MADRAS RECORD OFFICE.**Government of Madras.***Public works* **DEPARTMENT.**

G.O. No.	492	Press
396-398		~~Mis~~
Dated	18/2	1871

Red Hills Tank Bund. Piping

Section of Embankment and No 5 Leaks

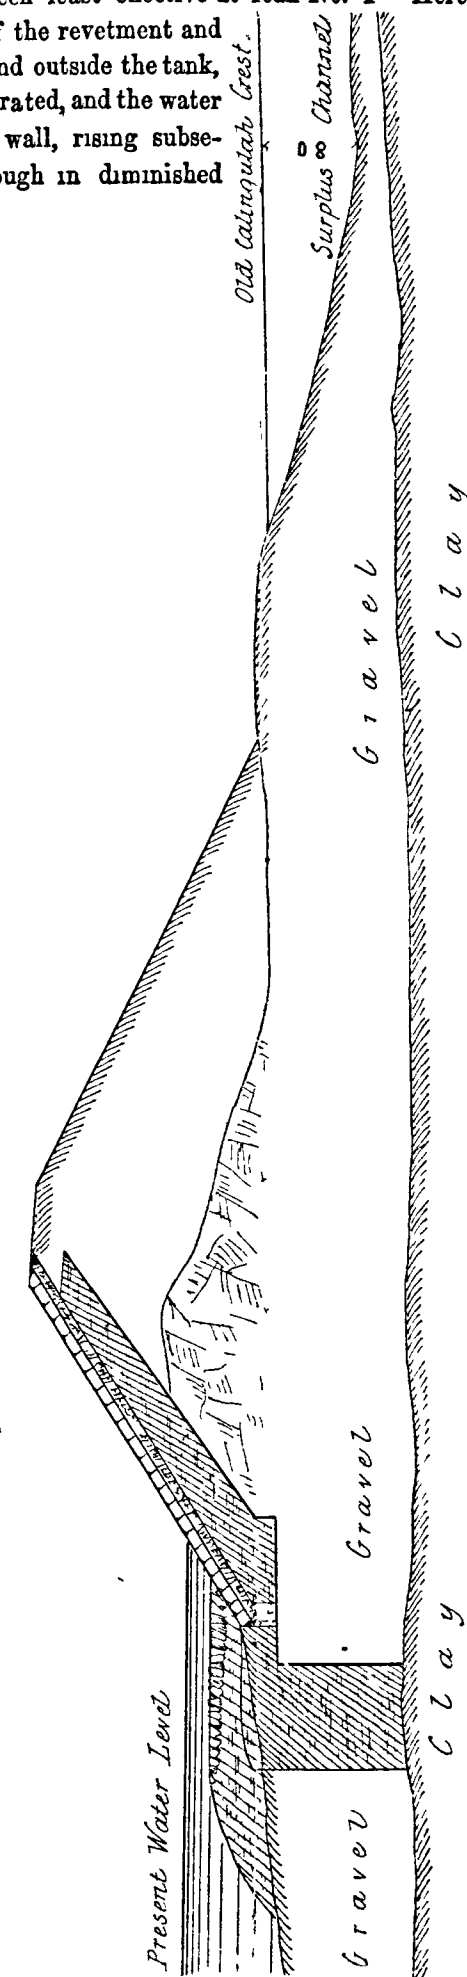
5 The effect of the puddling has been most satisfactory at leak No 5. At this point the section of the embankment and the ground on which it rests is that shown below. It will be seen that below a bed of gravel 14 feet in thickness clay was found, and that the puddle in the trench was connected with this clay

The puddle wall has been least effective at leak No. 1. Here, though it was carried down 12 to 15 feet below the toe of the revetment and 4 feet below the level of ground outside the tank, the bed of gravel was not penetrated, and the water appears to pass under the wall, rising subsequently to the surface, though in diminished quantity.

6 The conclusion to be drawn from the results of the work already executed as a guide for further operations would seem to be that the puddle wall should be carried, if possible, down to clay, or to a depth of not less than 10 feet below the level of the land outside the embankment

Exception will have, however, to be made at those parts of the ground when it is rocky, as an excavation of the depth, which would probably be necessary to reach the level here assigned, would be both tedious and expensive.

2. I agree with Captain Scott in considering that, where the sub-soil is rocky, the puddle trench need not be carried down to so low a level as elsewhere. Probably 3 feet below the level of the outside ground, where that is rocky and of the same character as the soil inside the tank, would do.
